# Technical Bulletin

Model: MET-C1k	)	e: 27-Nov-14	No.: RD147125		
Subject: Parts ch	nange information for BU3070	tray	Prepared by: E.I	Hinata	
From: 1st Tech S	Service Sect., MFP/P Tech Serv	vice Dept.			
Classification:	<ul> <li>Troubleshooting</li> <li>Mechanical</li> <li>Paper path</li> <li>Product Safety</li> </ul>	Part info	al	 □ Serv	n required ice manual revision ofit information 2

## BU3070 Bridge Unit

Gear position changed, grease added:

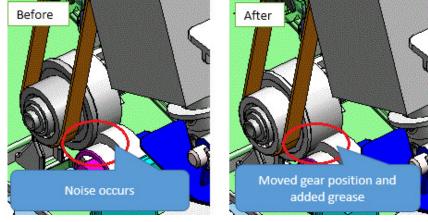
- 1) Bushings were added to the driven roller.
- 2) The position of the gear was changed and grease was added.
- 3) Some parts were deleted from service parts (but still included in assemblies). **See tables below.**

**Reason:** To minimize noise that may occur when the gear contacts the roller.

**IMPORTANT:** Due to the above changes, make sure to replace the cover, side guide plate, and roller shaft **together as a set.**

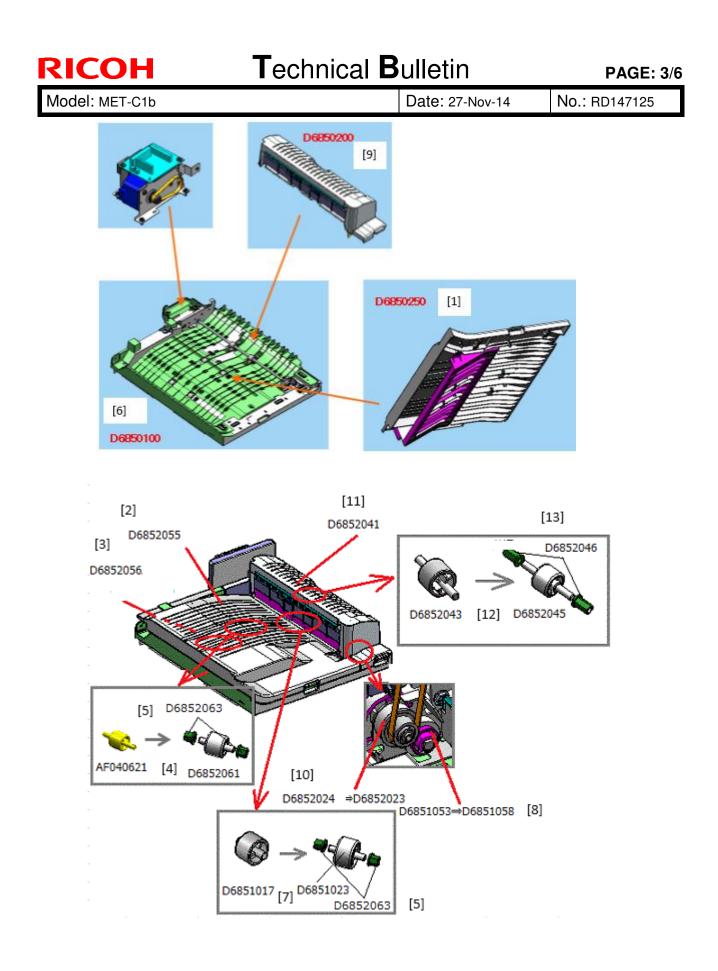
Ref .No	Old part number	New part number	Description	Old Q'ty	New Q'ty	Int
1	-	D6850250	COVER:LEFT:ASS'Y	-	1	-
2	D6852055	-	COVER:LEFT:OPEN AND CLOSE:UPPER	1	-	-
3	D6852056	-	GUIDE PLATE:LEFT:LOWER	1	-	-
4	AF040621	D6852061	ROLLER:DRIVEN:DIA14	4	4	X/X
5		D6852063	BUSHING:TRANSPORT:DIA4	-	8	-

**Note:** Parts #2 and #3 were deleted from service parts. Part #1 is the assembly which contains these two parts.

Ref .No	Old part number	New part number	Description	Old Q'ty	New Q'ty	Int
6	-	D6850100	FRAME SECTION	-	1	-
7	D6851017	D6851023	ROLLER:DRIVEN:DIA18	2	2	X/X
8	D6851053	D6851058	GEAR:Z21	1	1	X/O
5		D6852063	BUSHING:TRANSPORT:DIA4	-	4	-

Ref .No	Old part number	New part number	Description	Old Q'ty	New Q'ty	Int
9	-	D6850200	COVER:RIGHT:ASS'Y	1	1	X/O
10	D6852024	D6852023	GEAR:Z21:PULLEY:T21	1	1	X/O
11	D6852041	-	COVER:RIGHT:OPEN AND CLOSE	1	-	-
12	D6852043	D6852045	ROLLER:DRIVEN:EXIT	2	2	X/X
13	-	D6852046	BUSHING:EXIT:DIA4	-	4	-

Note: Part #11 was deleted from service parts. Part #9 is the assembly which contains this part.

Important: Install parts #4 (D6852061) and #5 together as a set.

Important: Install parts #7 (D6851023) and #5 together as a set.

Important: Install parts #12 (D6852045) and #13 together as a set.

## Side Tray Type M3

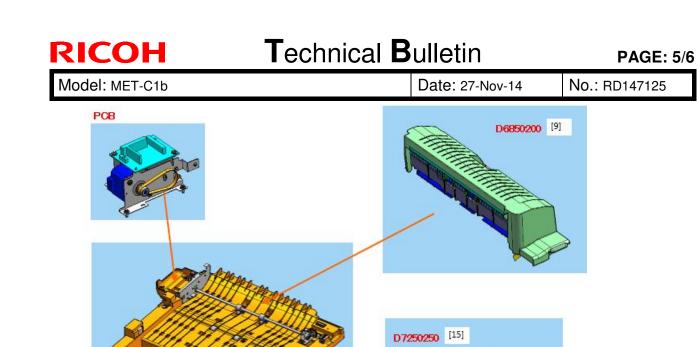
_	-	- / /	-				
		Old part number	New part number	Description	Old Q'ty	New Q'ty	Int
F	14	-	D7250100	FRAME SECTION	-	1	-
7	7	D6851017	D6851023	ROLLER:DRIVEN:DIA18	2	2	X/X
8	3	D6851053	D6851058	GEAR:Z21	1	1	X/O
Ę	5		D6852063	BUSHING:TRANSPORT:DIA4	-	4	-

Ref .No	Old part number	New part number	Description	Old Q'ty	New Q'ty	Int
15	-	D7250250	COVER:LEFT:ASS'Y	-	1	X/O
4	AF040621	D6852061	ROLLER:DRIVEN:DIA14	2	2	X/X
5	-	D6852063	BUSHING:TRANSPORT:DIA4	-	8	-
16	D7252051	-	COVER:LEFT:OPEN AND CLOSE	1	-	-
17	D7252057	D7252058	ROLLER:DRIVEN:EXIT:LEFT	2	2	X/X

Note: Part #16 was deleted from service parts. Part #15 is the assembly which contains this part.

Important: Install parts #7 (D6851023) and #5 together as a set.

Important: Install parts #4 (D6852061) and #5, #5 and #17 (D7252058) together as a set.

D7250100 [14]

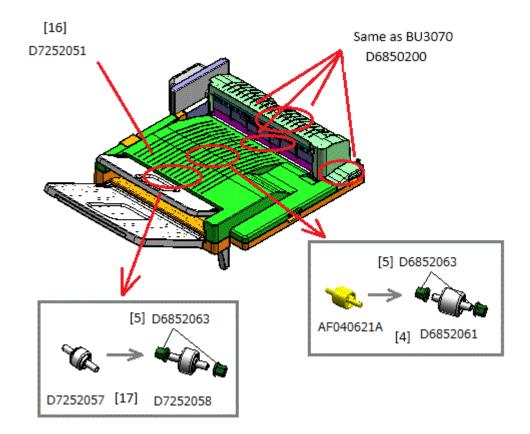
Ref .No	Old part number	New part number	Description	Old Q'ty	New Q'ty	Int
9	-	D6850200	COVER:RIGHT:ASS'Y	-	1	-
10	D6852024	D6852023	GEAR:Z21:PULLEY:T21	1	1	X/O
11	D6852041	-	COVER:RIGHT:OPEN AND CLOSE	1	-	-
12	D6852043	D6852045	ROLLER:DRIVEN:EXIT	2	2	X/X
13	-	D6852046	BUSHING:EXIT:DIA4	-	4	-

Note: Part #11 was deleted from service parts. Part #9 is the assembly which contains this part

Important: Install parts #12 (D6852045) and #13 together as a set.
